| Stage 04: Final Modification Report | | At what stage is this document in the process? |
| <h1>0581S:</h1> <h2>Amending the Oxygen content limit specified in the Network Entry Agreements at Grain LNG</h2> | | <div style="display: flex; flex-direction: column; gap: 5px;"> <div style="border: 1px solid #ccc; border-radius: 5px; padding: 5px; display: flex; align-items: center; gap: 5px;"> 01 Modification </div> <div style="border: 1px solid #ccc; border-radius: 5px; padding: 5px; display: flex; align-items: center; gap: 5px;"> 02 Workgroup Report </div> <div style="border: 1px solid #ccc; border-radius: 5px; padding: 5px; display: flex; align-items: center; gap: 5px;"> 03 Draft Modification Report </div> <div style="border: 1px solid #ccc; border-radius: 5px; padding: 5px; display: flex; align-items: center; gap: 5px;"> 04 Final Modification Report </div> </div> |
| <p>This modification will enable an increase to the oxygen content limit of gas permitted by the Network Entry Agreements (NEAs) at Grain LNG.</p> | | |

Analysis

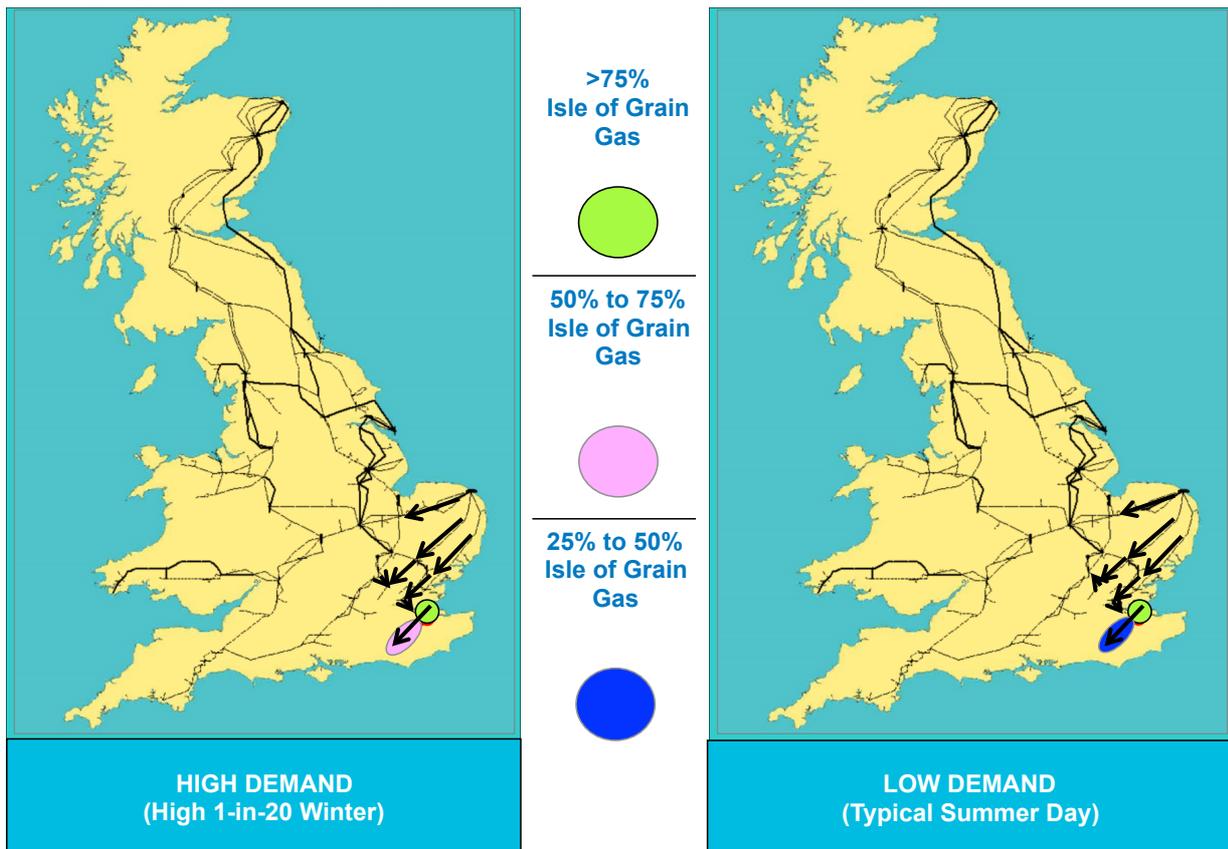
- The results of the 2015/16 modelling cycle were examined in order to determine the likely future penetration of Grain gas into the NTS
- The degree of penetration depends on a number of factors, particularly the seasonal and geographic pattern of supplies and demands

- Based on the latest available FES scenarios, we do not currently expect Grain LNG gas to either:
 - Penetrate beyond the south-east extremity of the NTS; or
 - Reach a UK storage facility connected to the NTS

Network Schematic of Isle of Grain Connection to the National Transmission System

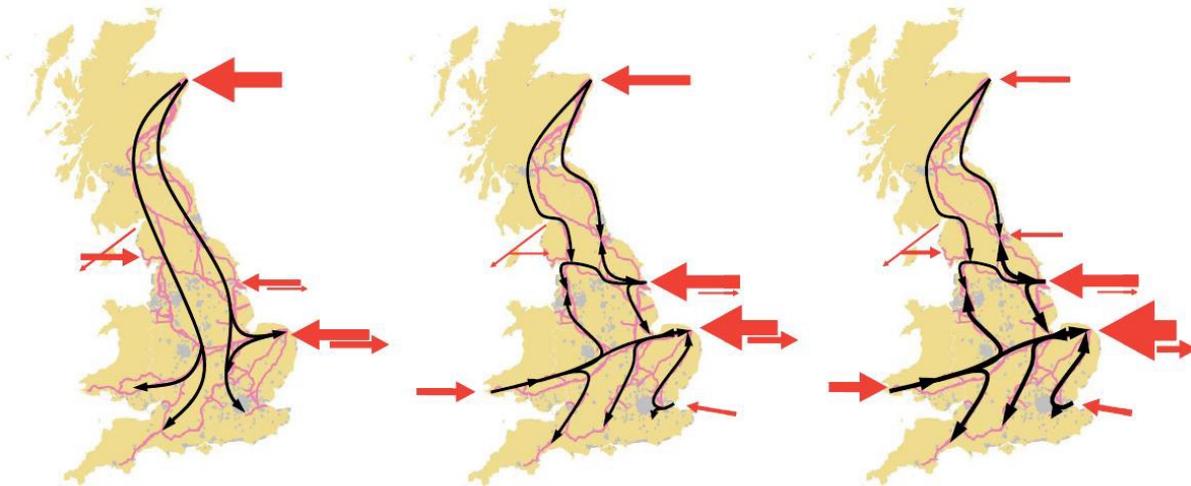
Under normal operation and gas demands gas flows south down Feeder 18 to supply the South East region. Under extreme conditions it is possible that transmitted gas could reach Avonmouth to the west however it is considered very unlikely, particularly with gas being supplied by South Hook and Dragon. If Bacton supplies were shut off due to maintenance or a major failure at Bacton terminal, it is possible that IoG gas could be transported north and exported via Interconnector to Europe. During the last 5 years IoG gas has been conveyed north along Feeder 5 to Horndon but has not been reported as far north as Yelverton, (approximately 30 miles south of Bacton). However network analysis on the previous five years revealed that the Exit Point may be in a position to export Isle of Grain originated gas to the continent on around 40 days per year. During the summer months, demand at the Exit Point for gas to reach the continent is higher. In order for the gas from Isle of Grain to reach the Exit Point, the Isle of Grain inputs in would have to be particularly high, as maybe the case as the IoG site is expanded. If flows from other entry points, for example Theddlethorpe and Easington, reduce then IoG gas may be more likely to be pushed further up the network.

Typical Gas Flow patterns: IGEM Industrial Affiliates – Kegworth, 9th November 2010

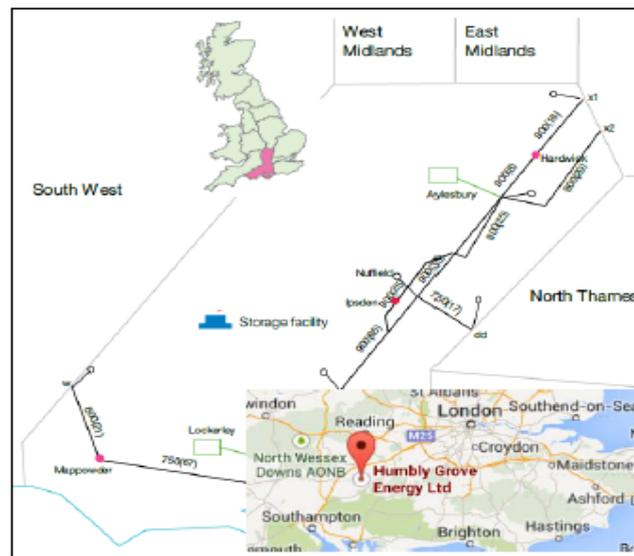
At an IGEM seminar in 2010 National Grid presented the following diagram indicating typical flow pattern for periods up to 2020. [5] Confirming the possibly that IoG gas could flow North but that flows west, towards Avonmouth, are unexpected.
